TECHNICAL SERVICE BULLETIN

Clicking/Creaking/Clunking/Rattle/Rotational Noise From The Front Strut Area When Turning The Steering Wheel

25-2574

This bulletin supersedes 25-2347. Reason for update: update the vehicles affected.

Figure 2

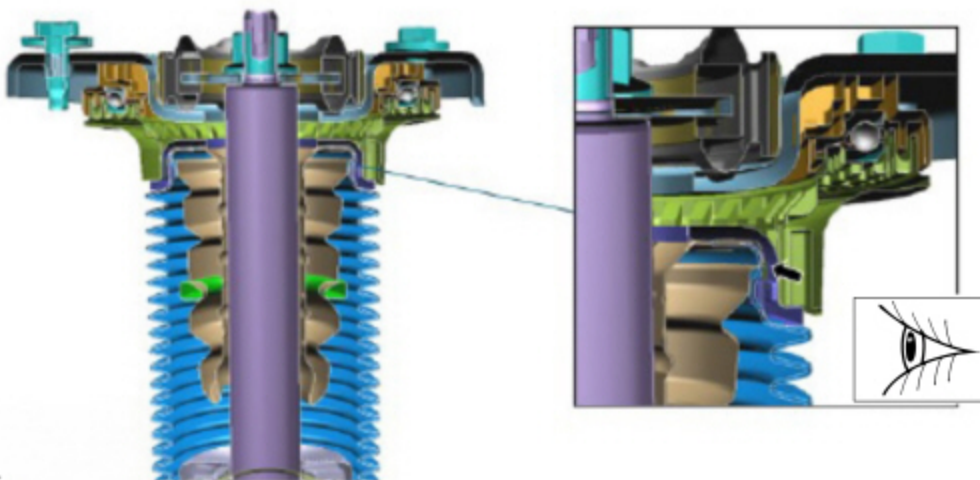
3. Install new front jounce bumpers.
4. Assemble the front strut and spring assemblies. Refer to the WSM, Section 204-01 Front Suspension > Disassembly and assembly.
 - (1). For installation, make sure the correct position and alignment between components is noted before removal. (Figure 2)

- (2). While compressing the front spring, a distinct clicking noise will be heard during the assembly of the front strut bearing, dust cover and front jounce bumper which indicates a proper assembly.
5. Reinstall the front strut and spring assemblies. Refer to the WSM, Section 204-01 Front Suspension > Removal and Installation.
